MODEL      }    254  
MODÈLE     }

We have in our production increased the material thickness around the screw holes for the cylinder cover on the crankcase.

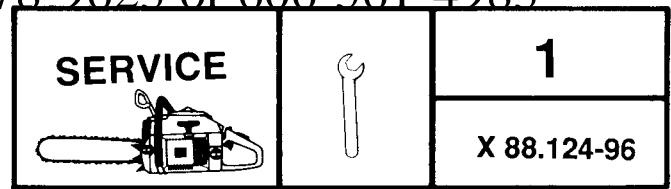
The change was introduced during spring -88 from the marking N on the drive side and R on the flywheel side of the crankcase.

Dans le carter moteur il y a maintenant plus de matériau autour des trous pour les vis du capot de cylindre.

Cette modification a été introduite au cours du printemps. Le nouveau carter est distingué par les repères N sur le côté embrayage et R sur le côté allumage.
